PREDETERMINATION SETTLEMENT AGREEMENT

CP# 10-19-74099
HUD# 07-20-2917-8

RIVERVIEW PLAZA INVESTMENTS, L.L.C.

Predetermination Settlement Agreement

Figure #1

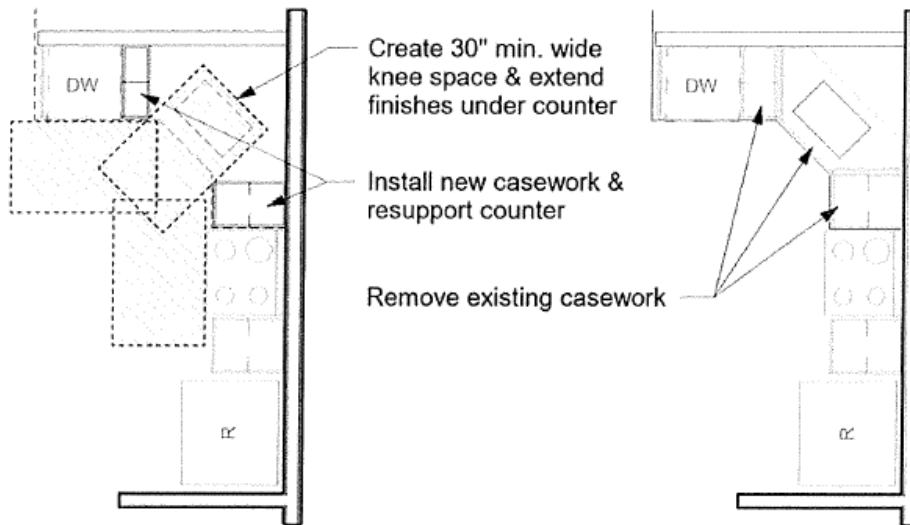
2. Claim: “In Unit 210, the cabinets under the kitchen sink were not [removable]; therefore, a person in a wheelchair would have to pull parallel to the sink to use it.”

Response: The cabinets under the sink in unit 210, 310, and 410 of 304 1st Ave. will be modified to be removable and pull up access. See figure #1.

Figure #2

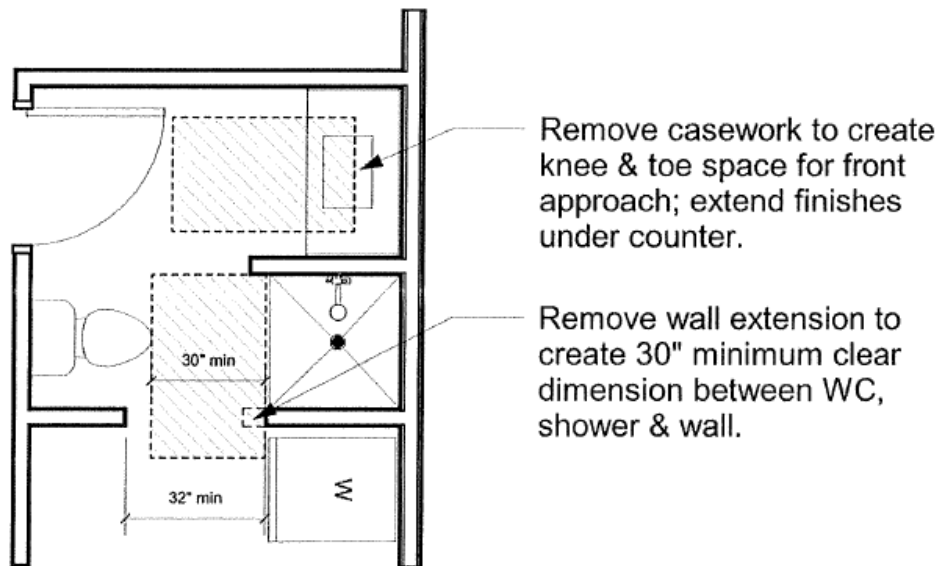
3. Claim: “In unit 210, the clear floor space at the shower stall measured 33” by 34”, which is less than the 30 by 48” which is required.”

4. Claim: “In unit 210, the entryway from the bathroom into the walk-in closet measured 28”, which is less than the 31-5/8” minimum.” See figure #2.

Response: We will modify the wall on the right side of the shower unit back to the shower flange to allow a parallel approach and a 30” x 48” clear space. See figure #2.

Response: The modifications noted in response to claim #3 will expand this opening by the necessary 3-5/8”. See figure #2.

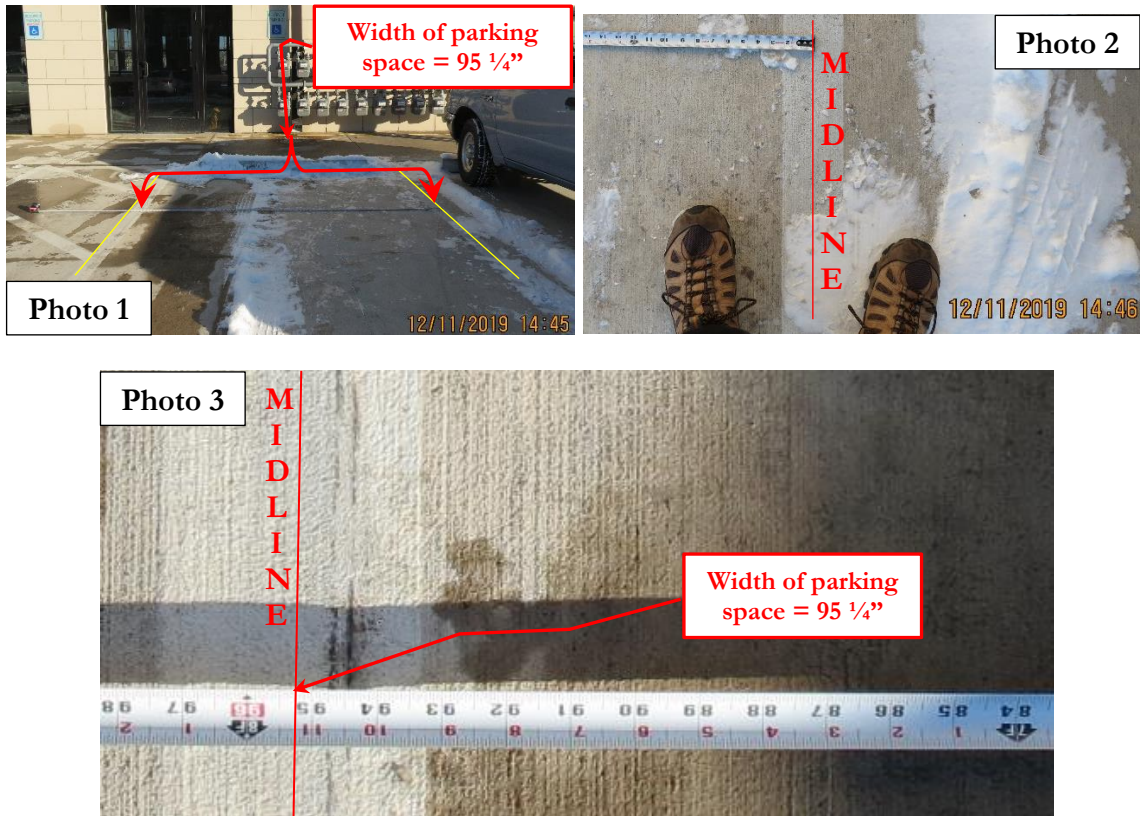
- 1) ICRC investigators measured the width of the parking space designated as reserved for use by persons with disabilities – which is adjacent to the south of the west building entrance – at 95 ¼". ICRC investigators took the following photographs to document their measurement (*see* Photos 1, 2, and 3):

The parking space was design to be painted such that the width between the striped paint lines measured 96” in compliance with the 96”-minimum width requirement. However, as painted, the width for this parking space is too narrow because it is less than the 96”-minimum width required in Section 502.2 of the ADAAG.

1) ICRC agrees with Respondents’ proposal to repaint the paint stripe bordering to the south of the parking space designated as reserved for use by persons with disabilities such that the width of both the paint stripe and the parking space will increase by 1” to bring it into compliance with the 96”-minimum width requirement from the 2010 ADAAG.

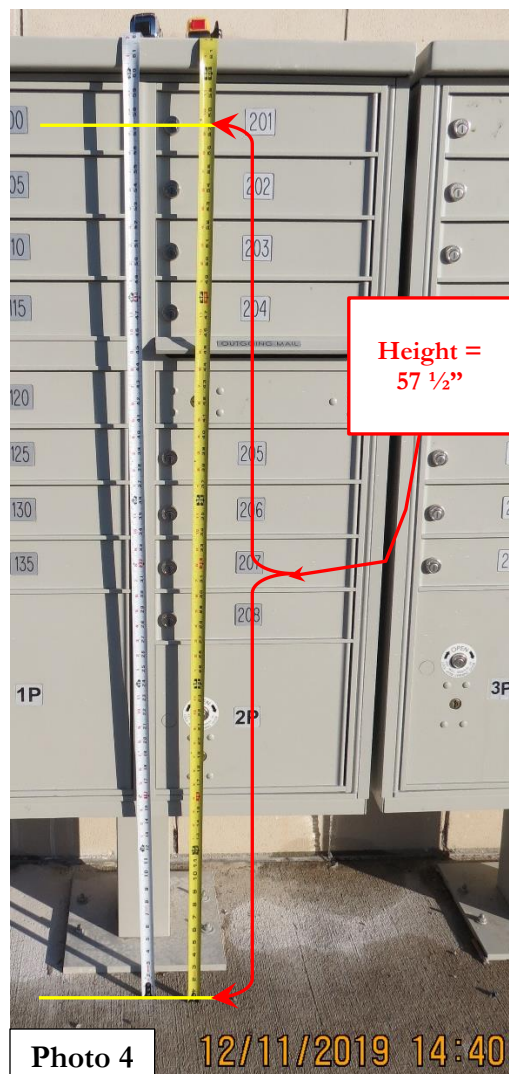
2) The mailbox kiosks containing the mailbox compartments for the 51 residential units at RP2 are located near to the south of the west building entrance. As this building has an elevator, all units are

There is sufficient clearance in front of all mailbox kiosks to allow for a parallel approach by persons using a mobility-assistive device such as a wheelchair. The height to the midline of the keyholes at the top row of mailboxes at the mailbox kiosks for RP2 units was measured at 57 ½” which is higher than the 54”-maximum for a parallel approach by persons using a wheelchair allowed by ANSI 1986.⁸

2) ICRC agrees with Respondents’ proposal coordinate with the Coralville Postmaster to swap the labels of the top row of residential mailboxes with the commercial mailboxes such that the height to the midline of the keyhole of the new location for the top row of residential mailbox compartments does not exceed 54”-maximum height.

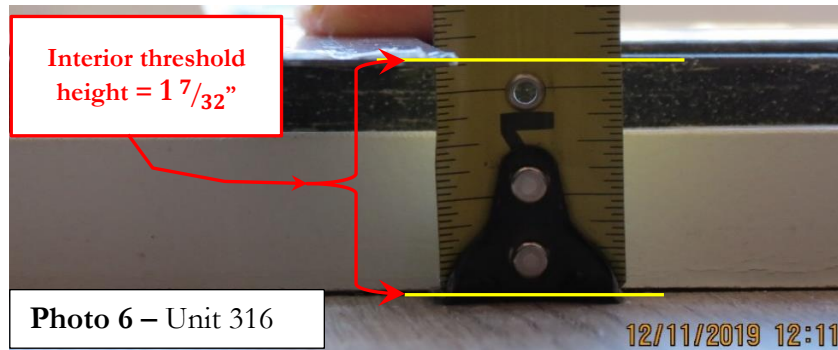
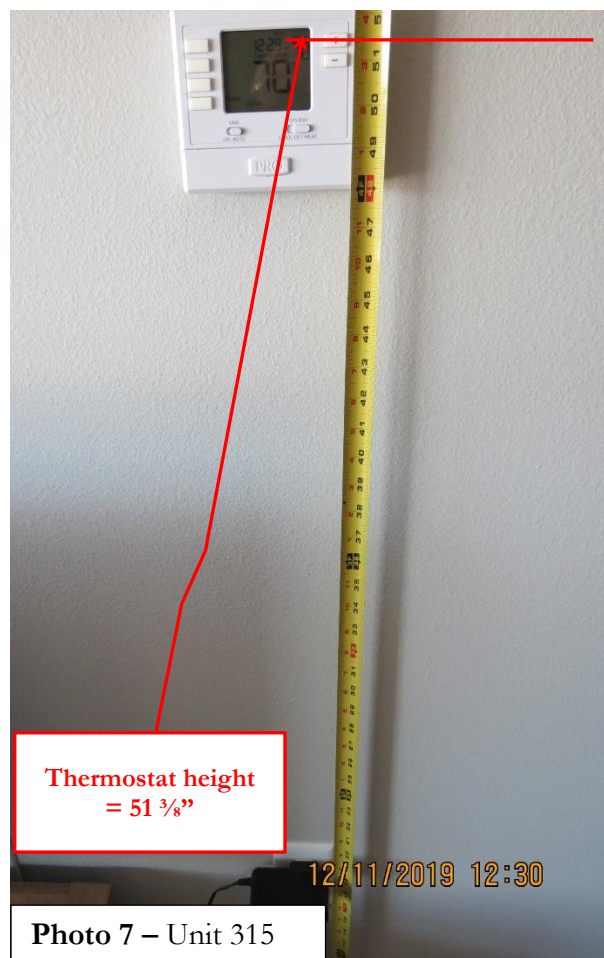
3) The following table lists the measurements obtained for the interior and exterior threshold heights at the sliding glass doorway onto the exterior surfaces of the balconies for all inspected units and the distance that the exterior surface is below the finished interior floor surface, which is calculated by subtracting the interior threshold height value from the exterior threshold height value. All interior threshold values are reported as numerical values because they exceed the ¼”-maximum height. However, if the resulting difference between interior and exterior threshold meets the above-stated requirements, they are labeled as “Compliant.” All values in the table below are expressed in inches.

All of the interior threshold heights listed in the table above exceed the ¼”-maximum allowed for thresholds without beveling.⁹ The exterior pervious surface adjacent to the secondary balcony entrance in Units 214, 312, and 316 was measured to be no less than 1 1/16” below the interior finished floor surface, which exceeds the ½”-maximum for balcony surfaces with pervious construction that is allowed by the Guidelines.

The plans submitted by Respondents did not include any instructions or diagrams about the threshold heights of doorways. The reported thresholds are too high, rendering them unusable by persons using wheelchairs.

3) ICRC agrees with Respondents’ proposal to install accessible ramps at the interior side of the thresholds of the sliding glass doorways. However, ICRC will require the ramps be installed at all units with non-compliant interior thresholds that exceed the 1/4”-maximum height, and without first requiring tenants to request the ramp. ICRC will require that the ramps be reinstalled at units where they were refused by the previous tenant and before the unit is shown to the next tenant. ICRC will allow Respondents to offer tenants the option to refuse the installation of the ramps, but will require Respondents to cease from

ICRC agrees with Respondents' proposal to measure and verify that the exterior pervious balcony surface is no more than 1/2" below the interior finished floor surface. At units where the balcony surface is too far below the interior finished floor surface, ICRC agrees with Respondents proposed retrofit to remove the decking, raise the balcony surface by installing additional framing, and then reinstall the decking to bring it into compliance with this accessibility requirement.

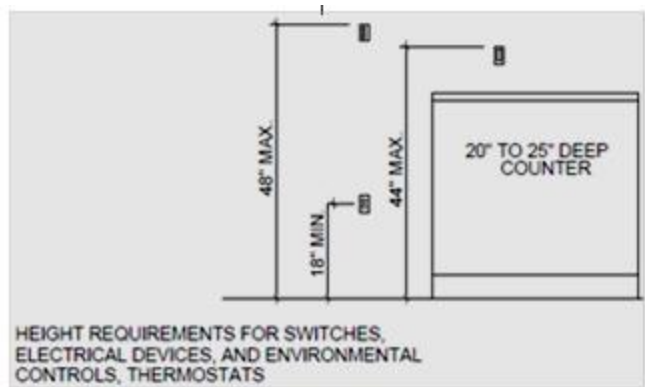
MEETING THE ACCESSIBILITY REQUIREMENTS OF THE FAIR HOUSING ACT” as one of the codes to follow in building RP2.¹¹ This sheet indicates thermostats were to be installed at 48” above the finished floor, as indicated in the following drawings and instructions:

If the thermostats had been installed according to the instructions on Sheet AG002, the height of the thermostats would have been compliant with the 48”-maximum height requirement. However, Sheet AG002 – where these instructions are given – indicates that these instructions are a “FINAL REVIEW SET” and “NOT FOR CONSTRUCTION.” Therefore, it is likely that the instructions in this sheet were missed when installing the thermostats in Units 315 and 404, which resulted in the height of these thermostats exceeding the 48”-maximum allowed. The thermostats in both of these units are too high, rendering them unusable by persons using wheelchairs.

4) ICRC concurs with Respondents' proposal to measure the height of thermostats and reinstall thermostats at or below the 48"-maximum height if the measured height of the thermostats exceeds 48".

Photo 8 – Unit 403

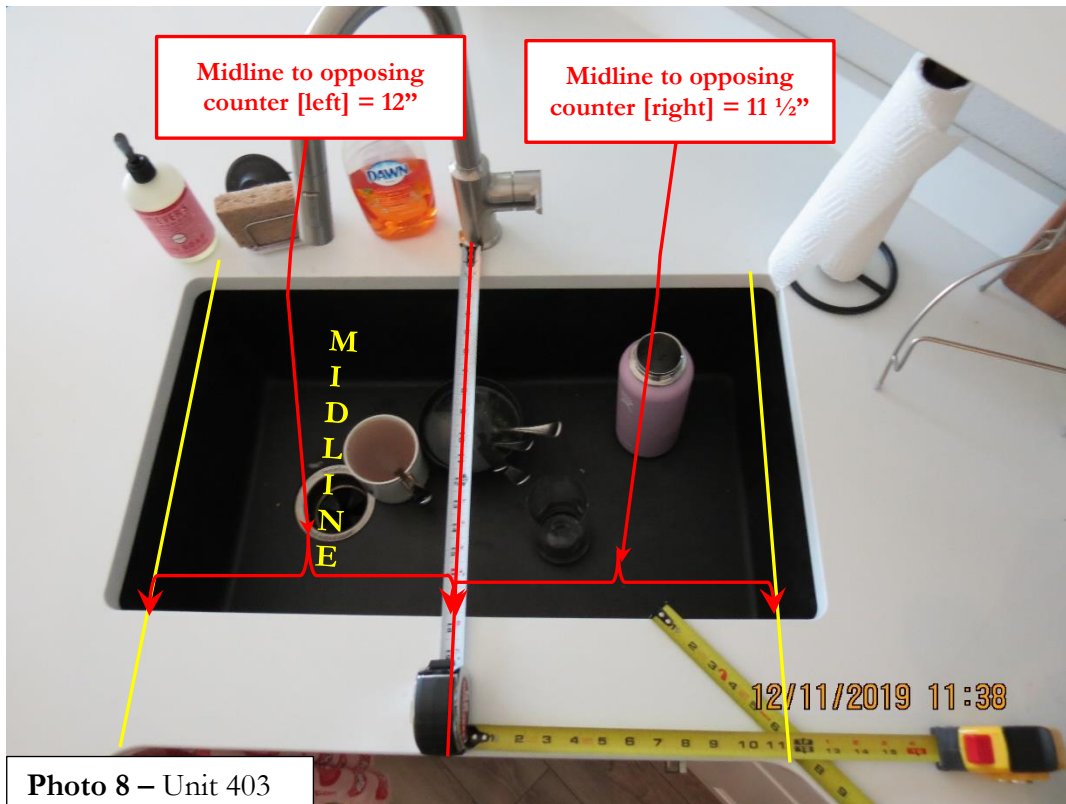
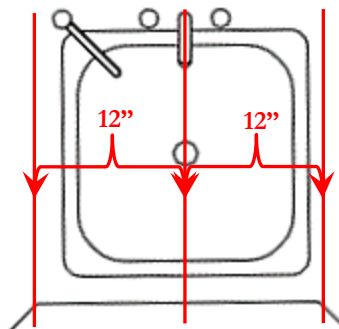
5) Measurements were taken from the midline of the kitchen sink to the closest opposing countertop in each of the inspected units to verify compliance with the 24”-minimum required clearance for a parallel approach, which is necessary if the cabinets are not removable. The midlines of the kitchen sinks were found to be less than 24 inches from the opposing countertop in four of the units. The following table indicates the unit numbers, floor plans, and the distance from the midline of the sink to the opposing countertops on both sides.

5) ICRC agrees with Respondents proposal to replace the base cabinets underneath and adjacent to the kitchen sink with removable cabinets so as to allow sufficient knee space that is required for a forward approach to the sink by persons who use a wheelchair. However, ICRC disagrees with the Respondents' proposal to only make this retrofit at 50% or 23 of the 46 units with the non-compliant kitchen sinks, as this would allow the remaining 23 units to remain inaccessible in violation of the ICRA and FHA. ICRC will require all 46 units to be retrofitted with the removable base cabinets in the manner proposed by Respondents.

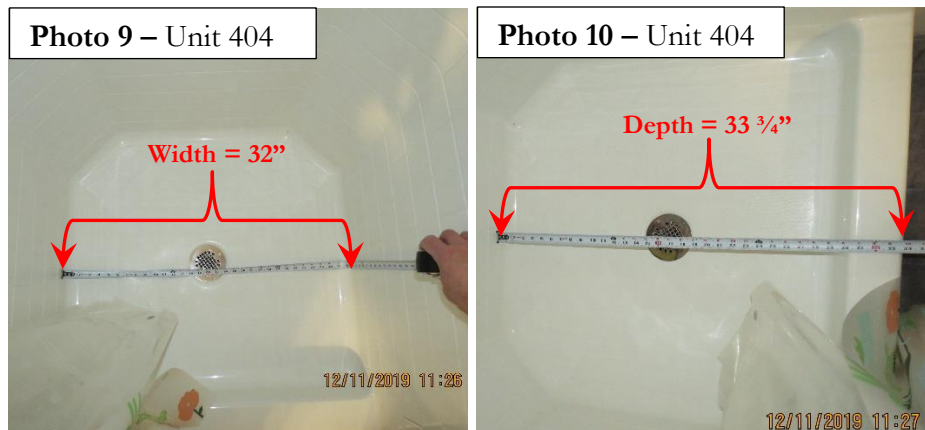
Respondents submitted construction plans of unit types E, C, F.1, and G drawn to a scale of 1/4" = 1'. The following is a screenshot of the plans for the kitchen sink that was copied and pasted from the design of unit type F.1, and is the same for the other three unit-types:

As shown above, the plans instructed the builder to install the sinks with 12" of clearance on both sides of the midline of the sink.

Therefore, as designed and built, this sink is unusable for persons who use a wheelchair for mobility because the midline of the sink is closer to the opposing countertops on either side than what is allowed by either the 15"-minimum for a forward approach or the 24"-minimum clearance that is required for a parallel approach.

The retrofit proposed by Respondents and cited on pages 2 and 3 of the current report – widen the clearance on either side of midline of the sink to 15" or more and modify the cabinets to make them removable – would be acceptable to ICRC and allow the affected kitchen sinks to be brought into compliance with the 15"-minimum clearance requirement.

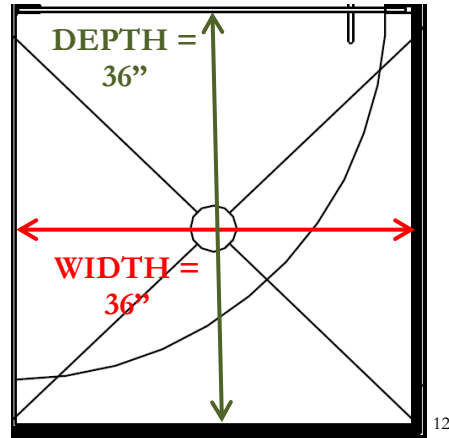
6) Unit 404 [B] has only one bathing facility. As indicated in the description of the requirement referenced above, the 35 1/2" by 35 1/2" minimum dimensions for shower stalls are measured between the interior side walls and from the interior side of the back wall of the stall to the entry edge, which make up the usable space at the interior of the shower stall.

The interior space at the shower stalls in units listed above was measured at 32" wide by 33 3/4" deep, which is less than the 35 1/2" by 35 1/2" minimum clearance required.

Based on this scaled drawing, the interior usable space of the shower stalls was designed to be 36” deep by 36” wide. If built as designed, the interior usable space of the shower stall in this unit would have been compliant with the 35 ½” by 35 ½”-minimum requirement. However, as built, this shower stall is unusable by persons who use a wheelchair.

6) ICRC agrees with Respondents' proposal to install a 36" x 36" shower base and tile walls with a minimum of 35-1/2" x 35-1/2" available clear floor space.

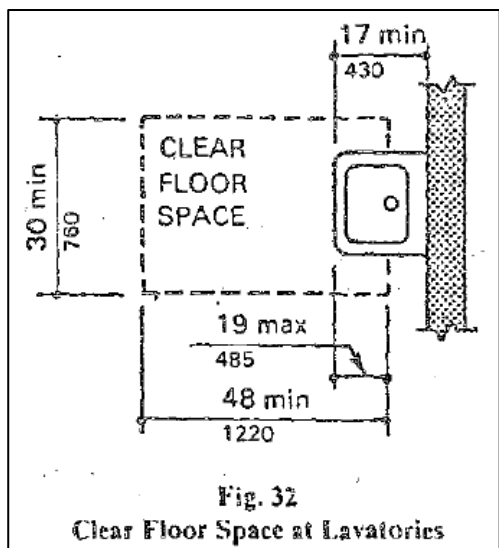
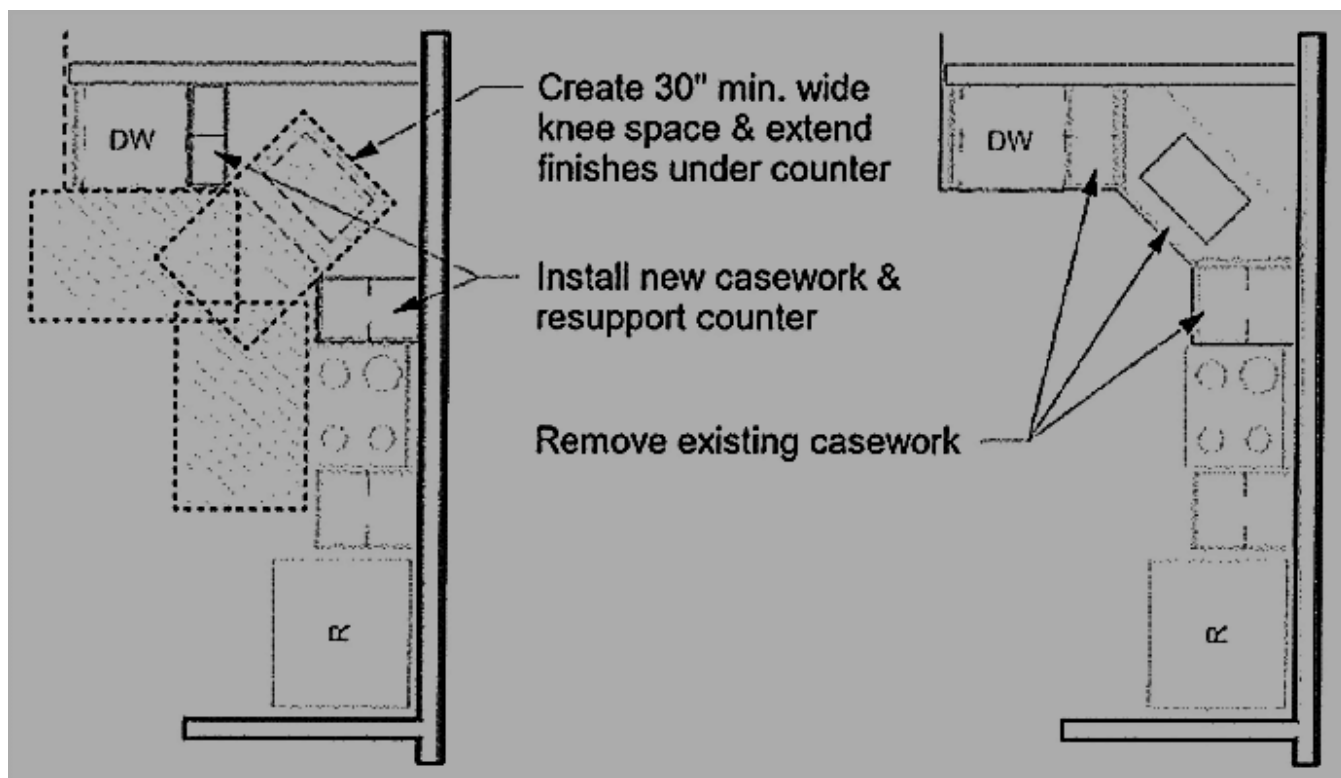
(a) The parties agree the distance from the midline of the sink to the opposing countertops on both sides of the sink in the kitchens of the units reported in the table on page 11 of the current agreement, was measured at under the 24”-minimum for kitchen sinks without removable cabinets and under the 15”-minimum required for kitchens with removable cabinets, as required by the Manual.

(b) Respondents agree to retrofit the kitchen sinks in the inspected units listed in “(a)” paragraph by (i) replacing three base cabinets – under the sink, and on both sides of the sink – with removable cabinets; and (ii) by finishing all surfaces that are not already finished – which would be visible if all three removable cabinets need to be removed to create the knee space required for a forward approach – including the flooring vinyl tiles of the closest possible design as the existing flooring, cabinet surfaces of the same design, and painted walls if exposed – such that the dimensions of the space created once the three removable base cabinets are removed for a tenant in a wheelchair, meet the “knee clearance” requirements from ANSI 1986, as indicated in the following figures.

Respondents agree to complete the above described retrofit in a manner consistent with the following illustration they submitted to ICRC:
